Access Compliance Report

Public Rights-of-Way

Intersection ID: 21664	Main Street: RED_ROCK_RD	Cross Street: SARDIS_RD_NORTH	Location: SE
ADA ID: F4229FC06DEB	Ramp Type: PerpDiag	Initial Pass/Fail: Fail	Overall Compliance: No
Severity Score: 13.75			
Codes/Mitigation Info/Possible Solution		Field Measurements/Component Compliance

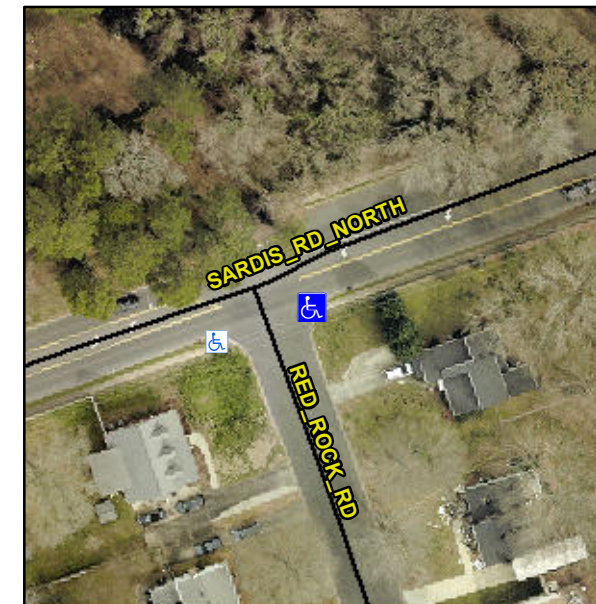
Compliance	Description	Data	Compliance	Description	Data
N/A	Ramp Length (in)	38.0	No	Ramp Slope (%)	9.4
Yes	Ramp Width (in)	48.0	No	Ramp XSlope (%)	3.4
N/A	Flare Type LT	N/A	N/A	Flare Type RT	N/A
N/A	Flare Slope LT (%)	N/A	N/A	Flare Slope RT (%)	N/A
N/A	Flare Traversable LT?	N/A	N/A	Flare Traversable RT?	N/A
N/A	Landing Length (in)	N/A	N/A	DWS Provided?	N/A
N/A	Landing Width (in)	N/A	N/A	DWS Contrast?	N/A
N/A	Landing Slope (%)	N/A	N/A	DWS Length (in)	N/A
N/A	Landing X Slope (%)	N/A	N/A	DWS Full Width?	N/A
N/A	Landing Curb? (Y/N)	N/A	N/A	DWS Offset (in)	N/A
N/A	Shared Landing?	N/A			
N/A	Gutter Ponding?	N/A	N/A	Gutter Slope (%)	N/A
N/A	Gutter Lip Ht (in)	N/A	N/A	Gutter X Slope (%)	N/A
N/A	Painted X Walk1?	No	N/A	Painted X Walk2?	No
	X Walk 1 Direction	To N		X Walk 2 Direction	To W
N/A	X Walk 1 Width (in)	N/A	N/A	X Walk 2 Width (in)	N/A
	X Walk 1 Slope (%)	3.7		X Walk 2 Slope (%)	3.1
	X Walk 1 X Slope (%)	4.1		X Walk 2 X Slope (%)	0.3

N/A	Ramp inside XWalk1?	N/A	N/A	Ramp inside XWalk2?	N/A
	Road Slope (%)	2.9	N/A	Clear Space?	N/A
	Road X Slope (%)	5.3	N/A	Clear Space to XWalk (in)	N/A
N/A	Any Obstructions?	N/A	N/A	Storm Grate/Utility Hazard?	N/A
	Obstruction Type			Storm Grate/Utility Type	
		N/A			N/A
		Yes		Surface Condition? (G/P)	Good

Remove & Replace Curb Ramp With Two New Directional Ramps or Equivalent.
